Informal document **GRE-84-37**  
84th GRE, 26-30 April 2021,  
agenda item 4 (e)

**Proposal for amendments to ECE/TRANS/WP.29/GRE/2020/8/Rev.2**

### **Revised proposal for a new [0x] series of amendments to UN Regulation No. 48**

6.2.6.1.2. **Vertical inclination limits of the cut-off**

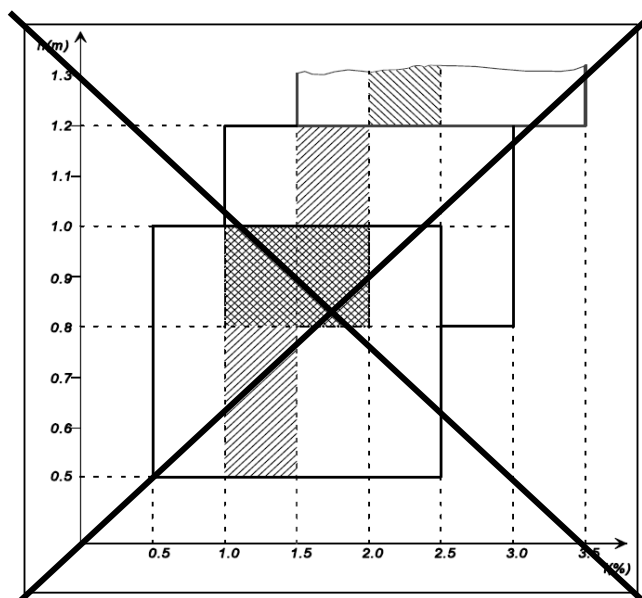
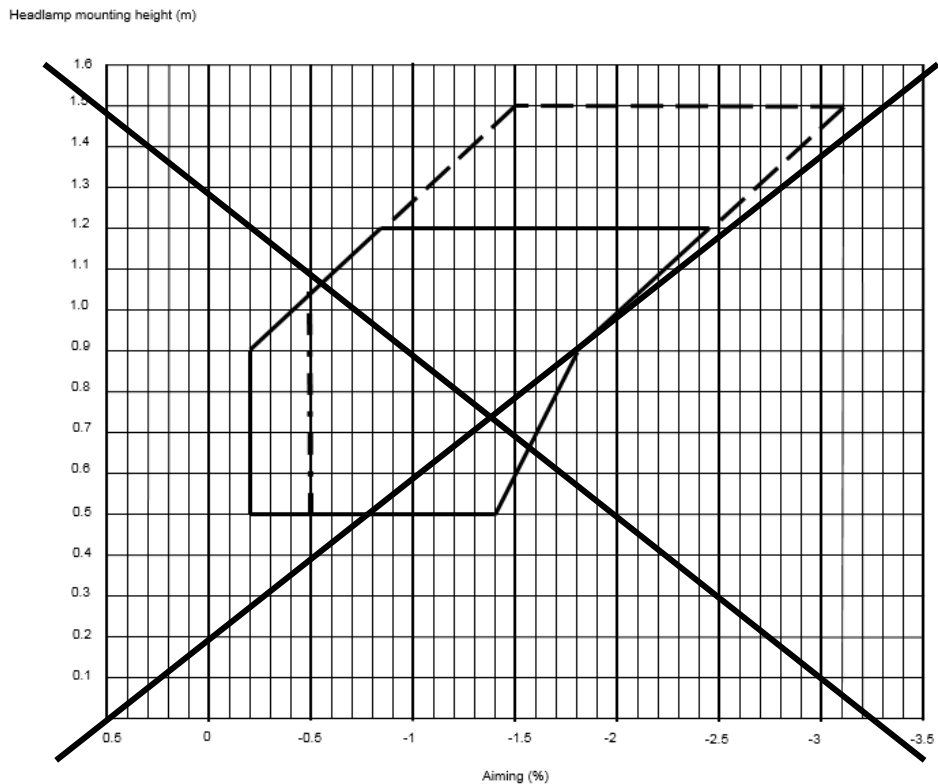
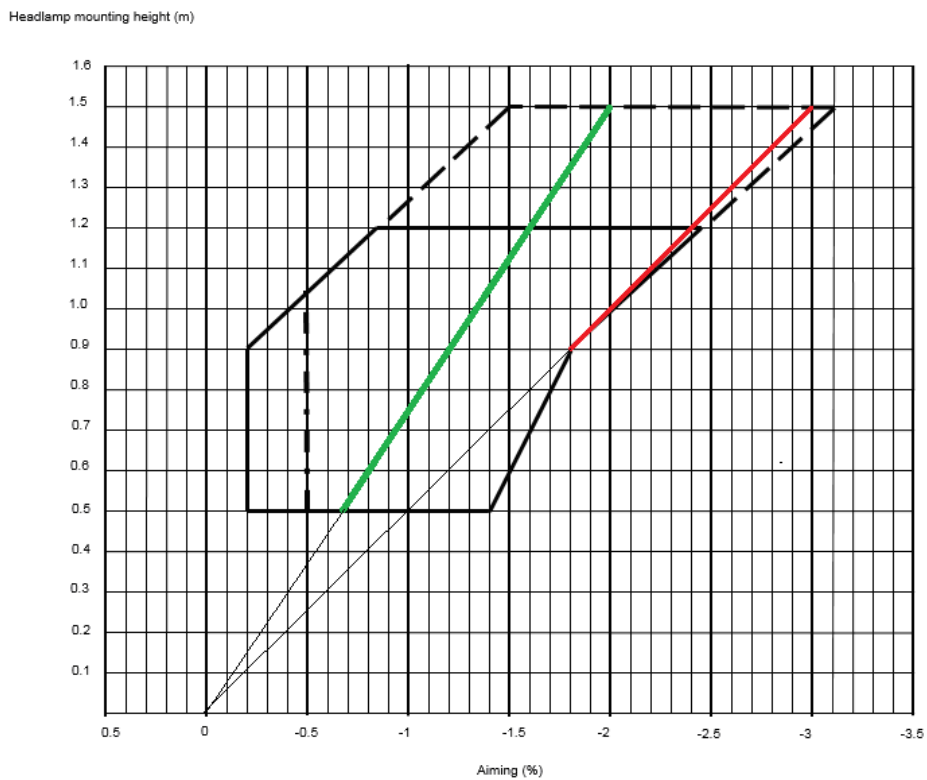
- set in the unladen vehicle state with one person in the driver's seat,
- specified within an accuracy of 0.1 per cent ~~by the manufacturer,~~ **according equation  $I = -h/0.75$  where I – cut-off inclination; h – mounting height of headlight optical axis (green line on drawing)**

Depending on the mounting height in meters (h) of the lower edge of the apparent surface in the direction of the reference axis of the **passing-beam (dipped-beam) headlamp**, measured on the unladen vehicles, the vertical inclination of the cut-off of the **passing-beam (dipped-beam)**, **starting from the initial downward inclination value set by the vehicle manufacturer as prescribed in paragraph 6.2.6.1.1.**, shall ~~under all the static conditions of Annex 5, remain between the following limits and the initial aiming shall have the following values;~~ **under all the static loading conditions of Annex 5:**

Mounting height $h$ [m]	Upper inclination limit [per cent]	Lower inclination limit [per cent]
$0.5 \leq h \leq 0.9$	-0.20	-1.40 to -1.80*
$0.9 < h \leq 1.2$	-0.20 to -0.85*	-1.80 to -2.45*
$1.2 < h \leq 1.5^{**}$	-0.85 to -1.50*	-2.45 to <del>-3.10</del> <b>-3.00*</b>

The above limits and the initial aiming values are summarized in the diagram below.

**“The controls for the headlamp-levelling devices referred to in paragraph 6.2.6.2.2. of this UN Regulation**

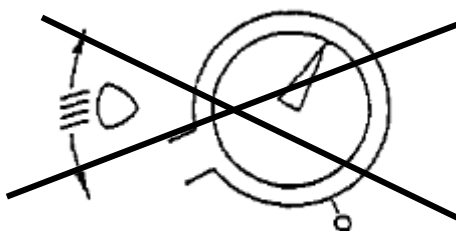
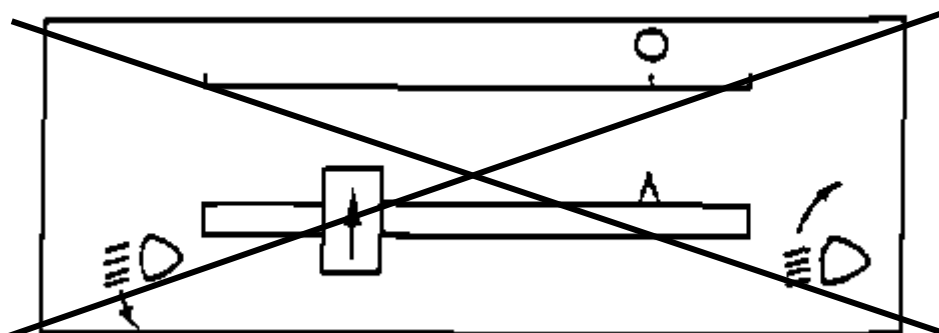
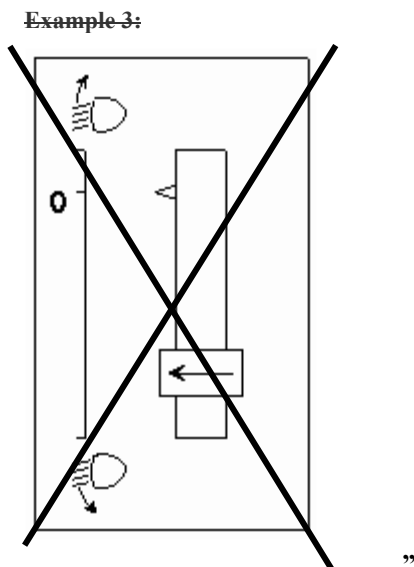
1. Specifications
  - 1.1. ~~Downward~~ Inclination of the dipped-beam shall in all cases be produced by a **simple control, the operation of which is clearly described in the owner’s handbook. in one of the following ways:**
    - (a) ~~by moving a control downwards or to the left;~~
    - (b) ~~by rotating a control in a counter clockwise direction;~~
    - (c) ~~by depressing a button (push pull control).~~

~~Symbols employing five lines instead of four may also be used~~  
~~Example 1:~~

~~Example 2:~~

- 'Downward' should be deleted. In the old text it is referring to the direction of the control device. For trucks dipped-beams are adjusted both upwards and downwards, due to different loading characteristics of different vehicle configurations.
- In order for the requirements to be technology neutral, the prescriptions of control methods (downwards, rotary, push-pull) have been deleted.
- The requirement in para. 1.3., referring to the owner's handbook, has been moved into the main regulatory text (see paragraph 6.2.6.2.2.[5].) and therefore can be deleted.
- The requirement in para. 1.4., specifying the symbols that can be used, has been deleted as these are already prescribed in UN Regulation No. 121.
- Examples of controls 1, 2 and 3 have been deleted, as the illustrations are considered outdated.
